Value Engineering Study Report

**Georgia Department of Transportation
NHS00-0000-00(763) _ P.I. No. 0000763
I-75 from Lowndes County line to SR 37
Phase II
Cook County**

RE: Submittal of the final Value Engineering Report
NHS00-0000-00(763) – P.I. No. 0000763
I-75 from Lowndes County line to SR 37 – Phase II
Cook County

T-02
TYPICAL SECTION-BRIDGE
(CR216/ADEL QUITMAN ROAD) (CR240/OLD COFFEE ROAD)

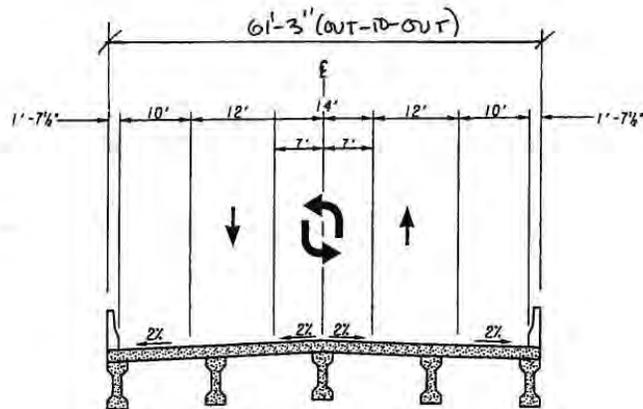
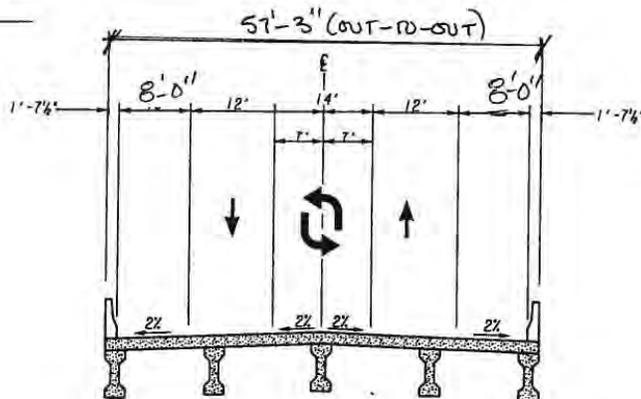
PROJECT:	Georgia Department of Transportation NHS00-0000-00(763) – P.I. No. 0000763 I-75 from Lowndes County line to SR 37 – Phase II Cook County	ALTERNATIVE NO.:	BR-1
DESCRIPTION:	Use an 8'-0" shoulder in-lieu of 10'-0" shoulder on the bridges	SHEET NO.:	1 of 4

The original design calls for an overall out-to-out width of 61'-3". The original bridge out-to-out width will provide two 12'-0" traffic lanes (two in each direction), a flush median with one 14'-0" inside turning lane and two 10'-0" shoulders.

The proposed alternative calls for an overall out-to-out width of 57'-3". The proposed out-to-out width will provide two 12'-0" traffic lanes (two in each direction), a flush median with one 12'-0" inside turning lane and two 8'-0" shoulders.

The 8'-0" outside shoulders will be more than adequate and within requirements for bridges of this length, per AASHTO Geometric Design of Highways and Streets (pgs. 224, 315, 412, 455 & etc.).

**T-02
TYPICAL SECTION-BRIDGE
(CR216/ADEL QUITMAN ROAD)**

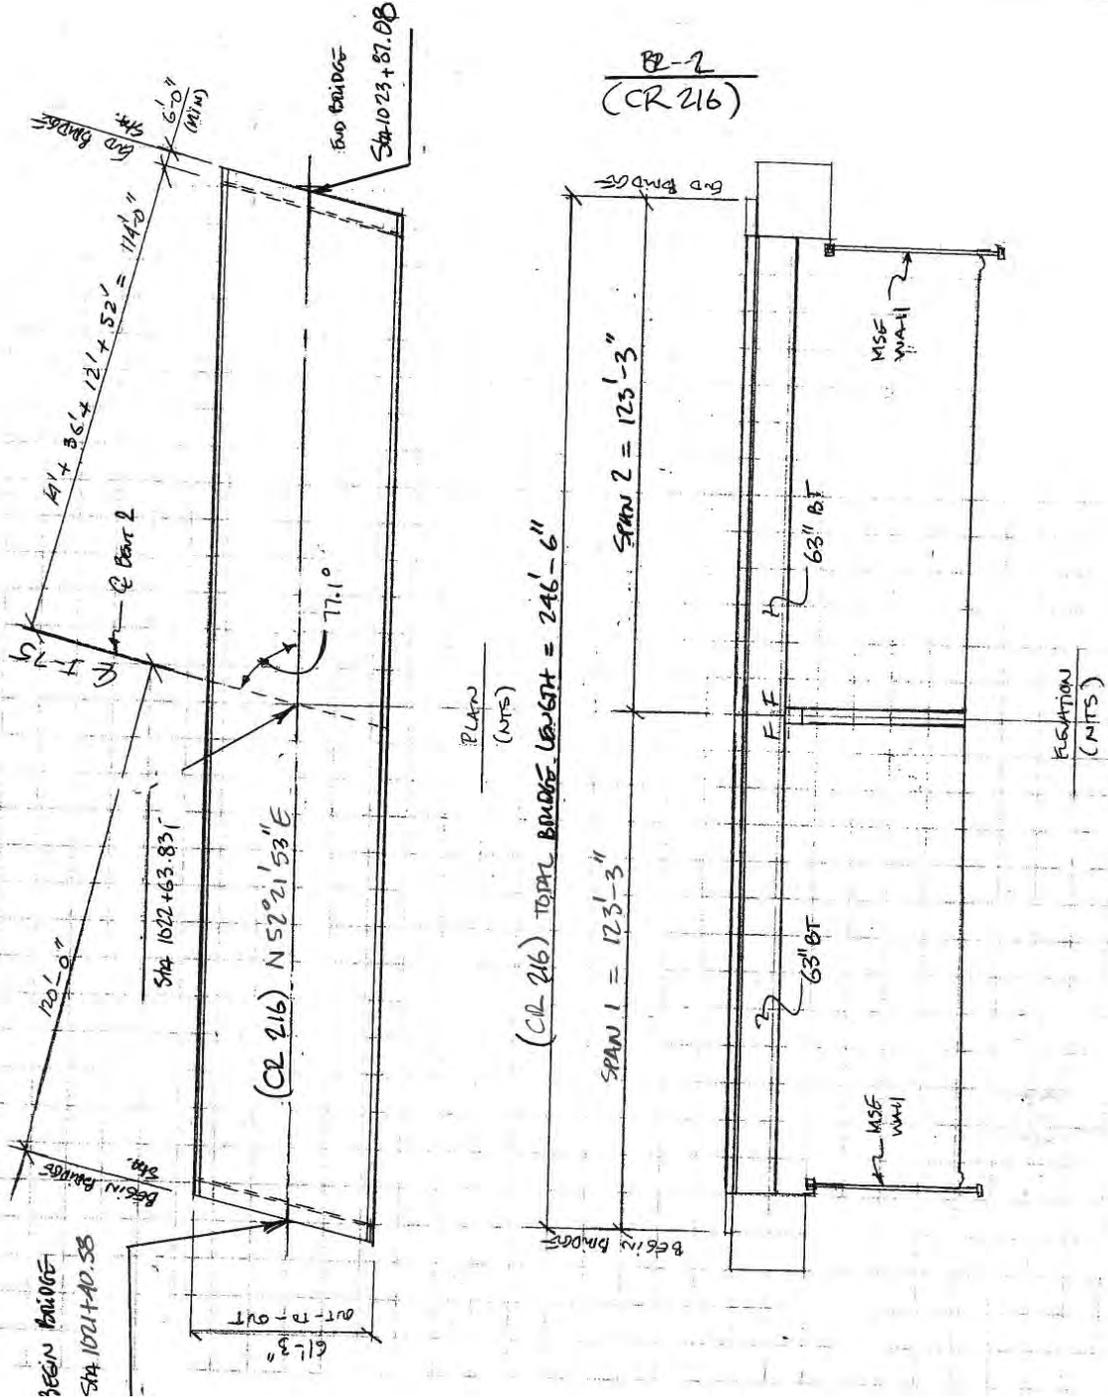
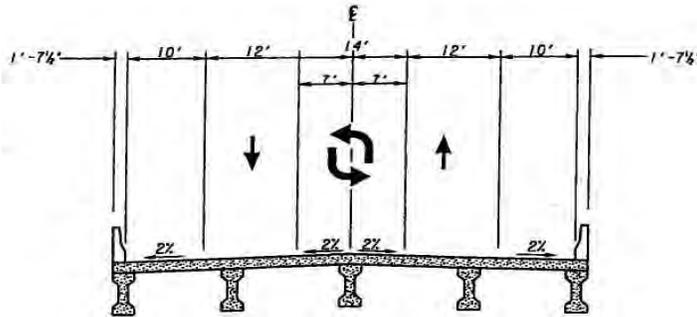
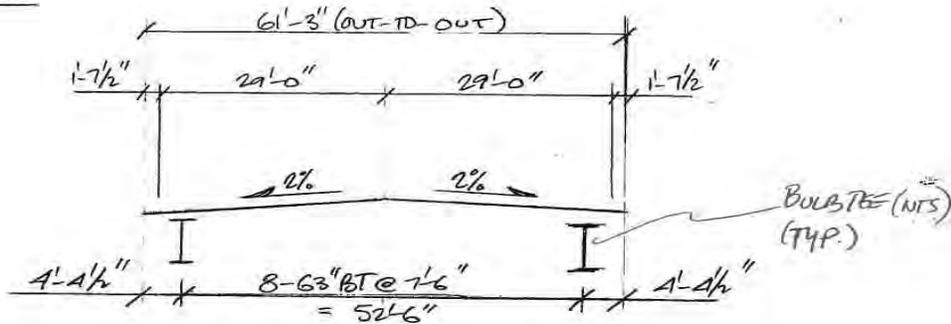
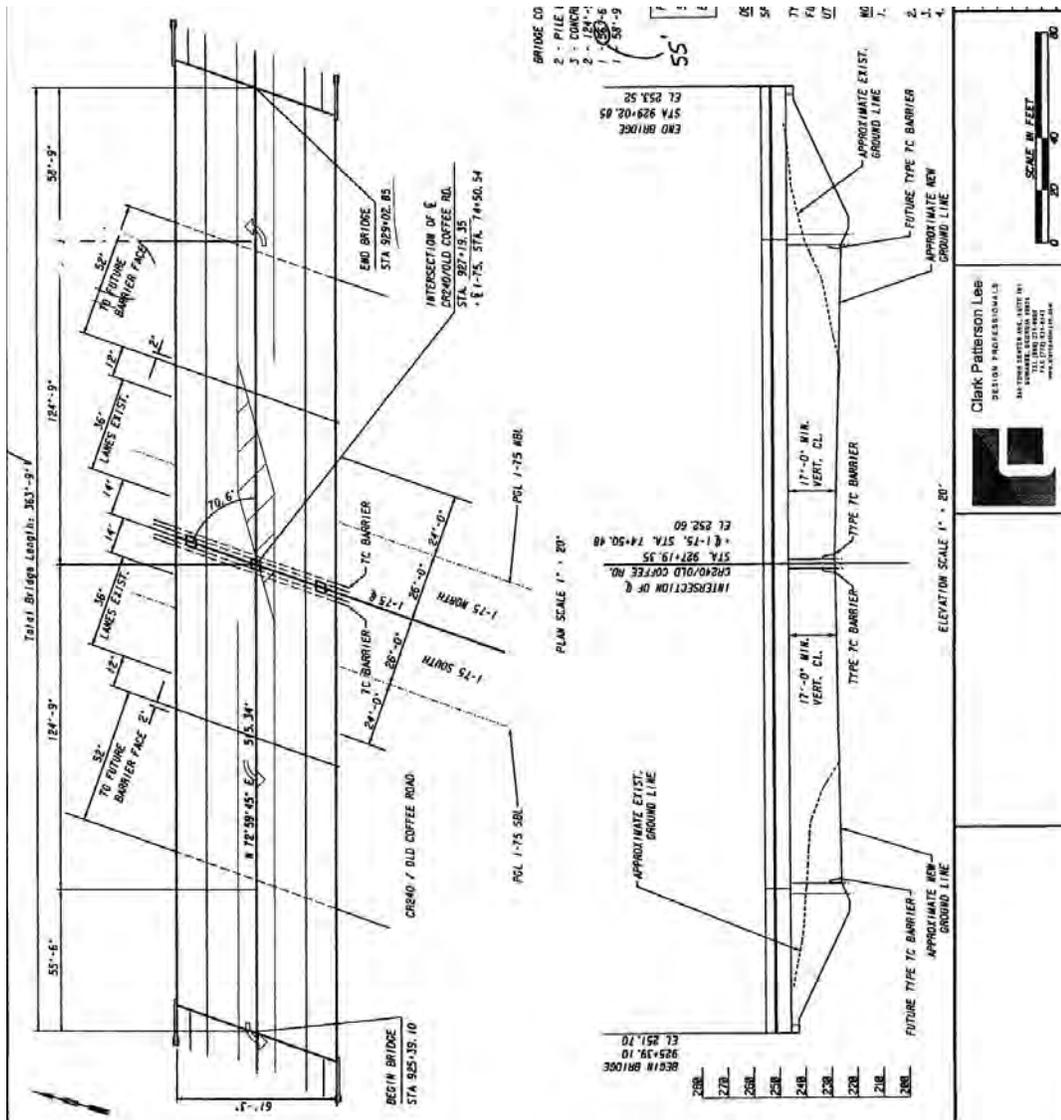
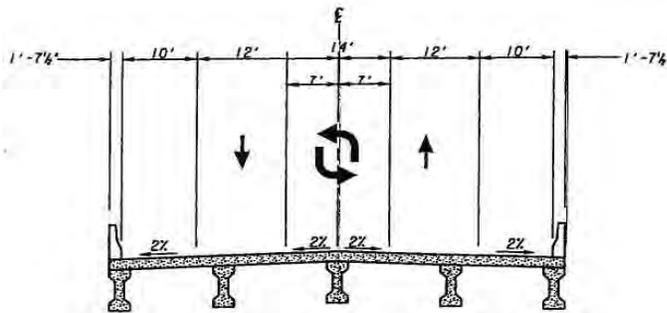
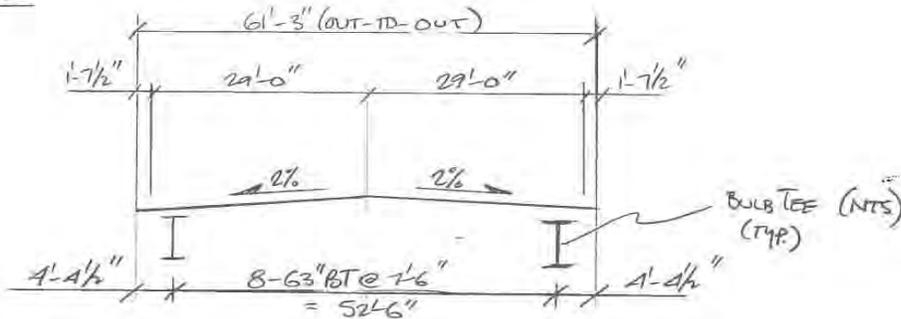
PROJECT:	Georgia Department of Transportation NHS00-0000-00(763) – P.I. No. 0000763 I-75 from Lowndes County line to SR 37 – Phase II Cook County	ALTERNATIVE NO.:	BR-2
DESCRIPTION:	Use two-span structures with MSE walls in-lieu of four span structures	SHEET NO.:	1 of 12

The current design calls for a four span 363.75' (CR240) long and 354.50' (CR 216) long bridge structure over I-75. The two bridges will have a CIP superstructure supported by PSC 63" Bulb Tee beams. The overall out-to-out width is 61'-3" and it will provide two 12'-0" traffic lanes (one in each direction), a flush median with one 14'-0" inside turning lane and two 10'-0" shoulders. The bridges will be skewed with all bents parallel to the CL of I-75.

The alternative calls for the reduction in length for the proposed bridge structures by the use of a two span bridge with MSE walls at the end bents. The proposed CIP superstructure will be supported by 8 - PSC 63" Bulb Tee beams spaced at 7'-6". The typical section for proposed structures will match the original design. The bridges will be skewed with all bents parallel to the CL of I-75.

The proposed alternative will reduce the overall bridge length from 363.75' to 254.50' at CR 240 and from 354.50' to 246.50' at CR 216. End bent protection barriers used in the current design will be used to protect the MSE Walled abutments as well, thus offsetting the costs for this item. Both the current design and this alternative design will accommodate all future widening of I-75.

T-02
TYPICAL SECTION-BRIDGE
(CR216/ADEL QUITMAN ROAD) (CR240/OLD COFFEE ROAD)

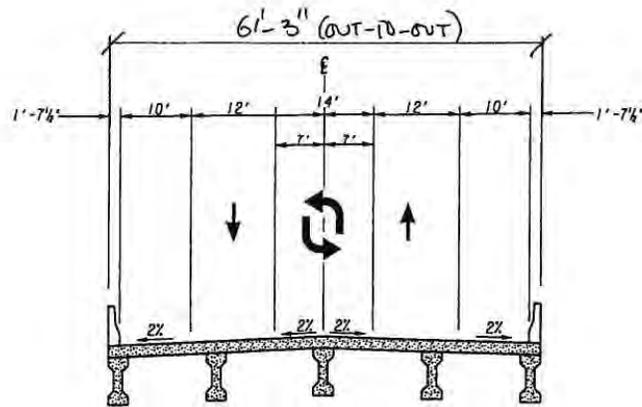
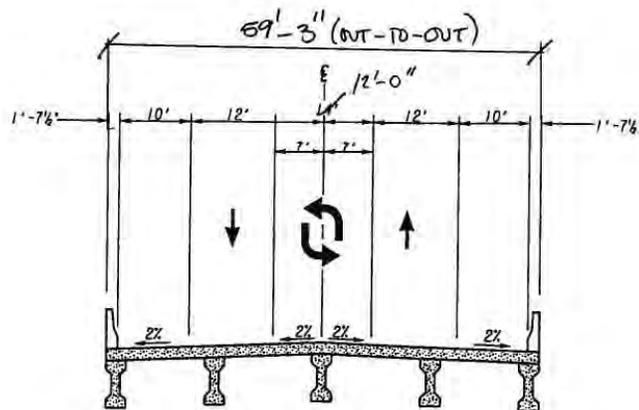
DESCRIPTION: **Use 12' turn lanes on the bridges**

The original design calls for an overall out-to-out width of 61'-3". The current bridge out-to-out width will provide two 12'-0" traffic lanes (two in each direction), a flush median with one 14'-0" inside turning lane and two 10'-0" shoulders.

The proposed alternative calls for an overall out-to-out width is 59'-3". The proposed out-to-out width will provide two 12'-0" traffic lanes (two in each direction), a flush median with one 12'-0" inside turning lane and two 10'-0" shoulders.

In consideration of the nominal traffic load, it appears reasonable to only construct a 12'-0" turn lane in-lieu of the 14'-0" turn lane proposed. Additionally, there is not a significant truck volume. Also, as this project is only for a two lane with turn lanes, it would be easy in the future, should traffic volumes require a four lane section to provide additional width at that time. It is noted that current designs typically only require 11' through lanes and 12' turn lanes and that with such low traffic volumes, 12' should be responsible.

T-10
TANGENT SECTION - RAMP

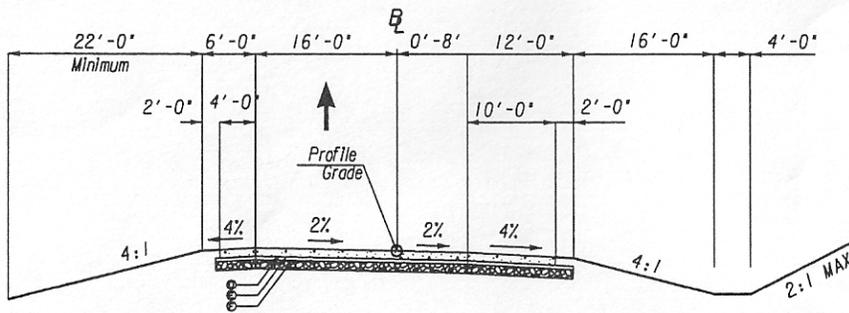
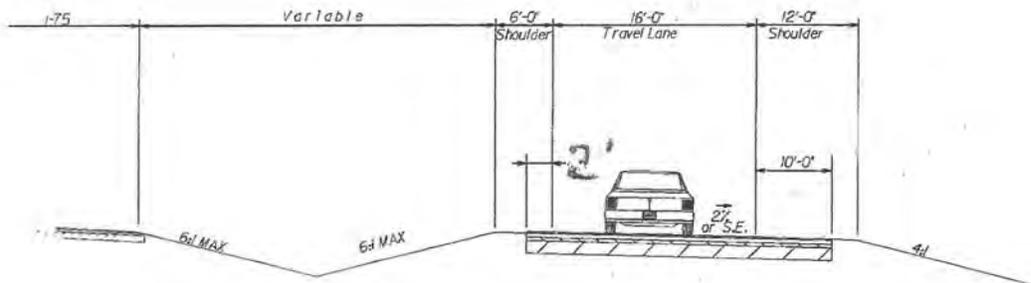
PROJECT:	Georgia Department of Transportation NHS00-0000-00(763) – P.I. No. 0000763 I-75 from Lowndes County line to SR 37 – Phase II Cook County	ALTERNATIVE NO.:	RD-1
DESCRIPTION:	Reduce the sum of the ramp shoulders from 14'-0" to 12'-0"	SHEET NO.:	1 of 4

The original design proposes a 4'-0" left shoulder and a 10'-0" right shoulder for a sum total of 14'-0".

The alternative design would propose utilizing either a 2'-0" left shoulder and a 10'-0" right shoulder or a 4'-0" left shoulder and an 8'-0" right shoulder.

According to AASHTO's Policy on Geometric Design of Highways and Streets (Page 838), for one way ramps, "the sum of the left and right shoulder widths should not exceed 10'-0" to 12'-0" feet". While a 4'-0" inside shoulder or a 10'-0" outside shoulder is acceptable under the guidelines combining the two maximum allowable values exceeds the value recommended by AASHTO.

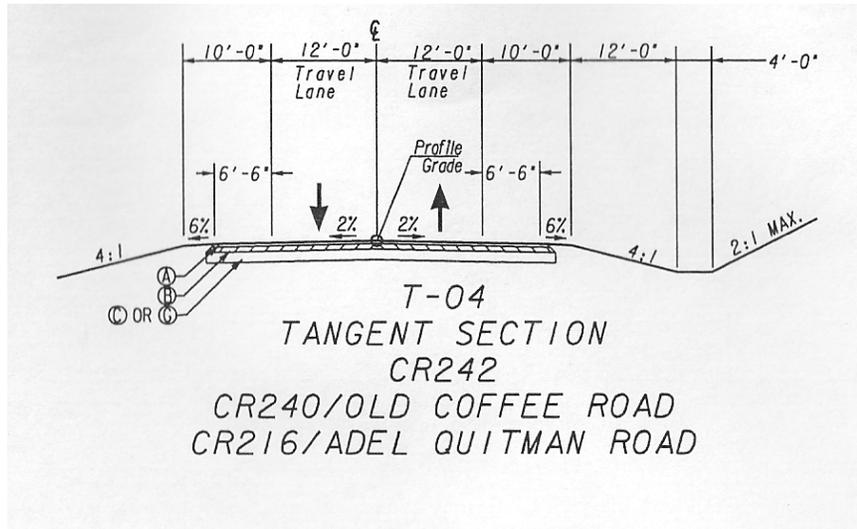
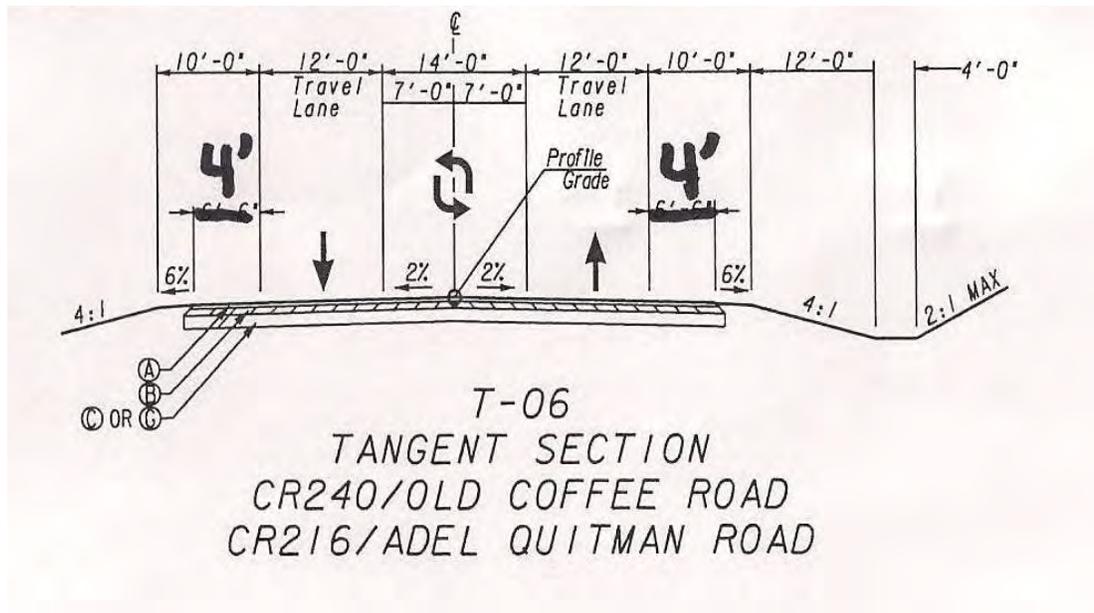
PROJECT:	Georgia Department of Transportation NHS00-0000-00(763) – P.I. No. 0000763 I-75 from Lowndes County line to SR 37 – Phase II Cook County	ALTERNATIVE NO.:	RD-2
DESCRIPTION:	Use a 4'-0" paved shoulder in lieu of a 6'-6" paved shoulder	SHEET NO.:	1 of 5

The original design provides a 6'-6" paved shoulder on CR-216 and CR-240.

The alternative design would provide a 4'-0" paved shoulder on CR-216 and CR-240.
